POLICY REPORT DEVELOPMENT AND BUILDING

TO: Vancouver City Council
FROM: Director of Planning
SUBJECT: CD-1 Rezoning: 2667-2703 Kingsway

DRAWING TITLE
North Elevation

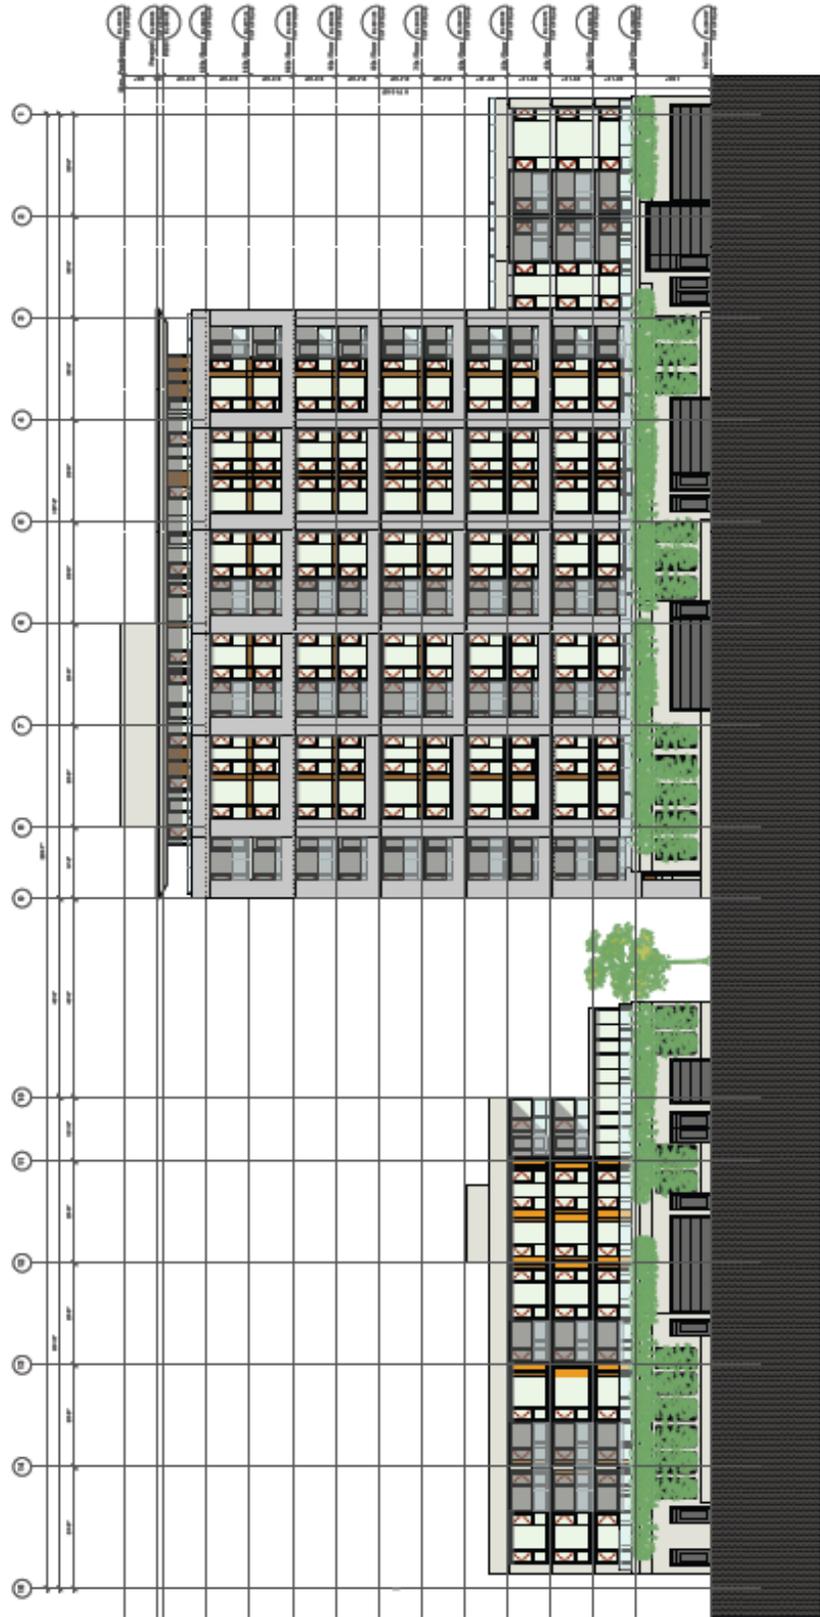
11. design development to provide safe access for planter maintenance and greater amenity to the second floor patios;

Note to Applicant: This can be achieved by raising the planters currently located mid-way up the north façade (see Sections B-B and C-C on drawing A-4.1) to the level of the 2nd floor patios. These planters should include some trailing plants capable of draping over the planter edge and down the exposed face of the building.
